## Service Bulletin SB.JS-003

Cable Release System

MODEL	SERIAL NUMBERS
JS-1A	002, 003, 005, 009
JS-1B	006, 007, 008, 010, 011, 012, 014, 015, 019, 021 - 024

Figure 1 Application of 53.5 kg load on release handle.

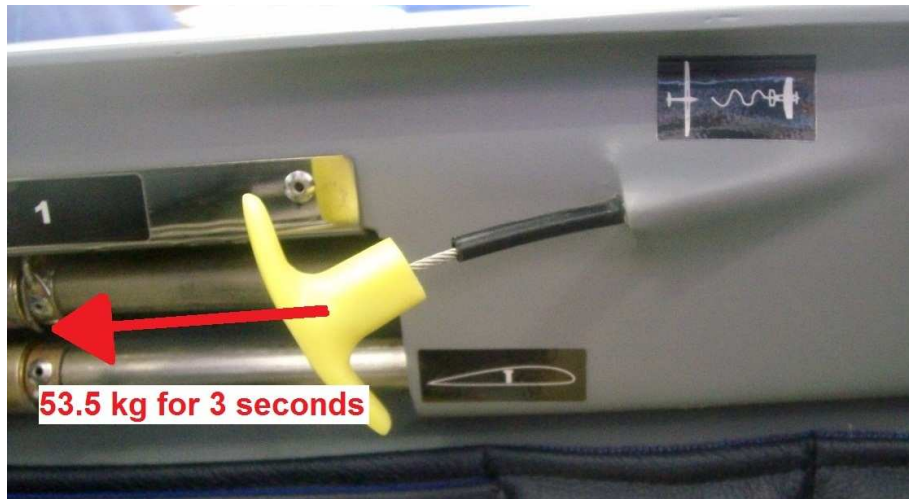
During the factory production test for JS1B-020 on the 8<sup>th</sup> of December 2010 at Potchefstroom Airfield the nose release pulley sleeve (Part # 1A-1.13.40.11) failed which resulted in the cable release handle (Part # 1A-1.13.10) coming loose.

**MANDATORY:** A once off 53.5kg load test must be completed at a sailplane's next scheduled maintenance.

A spring scale or load cell are required for the load test of the cable release system. The ultimate load of 53.5kg must be applied to the release handle for three seconds in the direction of pilot operation as shown in Figure 1 below:

Failure of any stop in the system will be immediately noticeable and the Factory shall be contacted for the corrective action before the sailplane may be released to service.
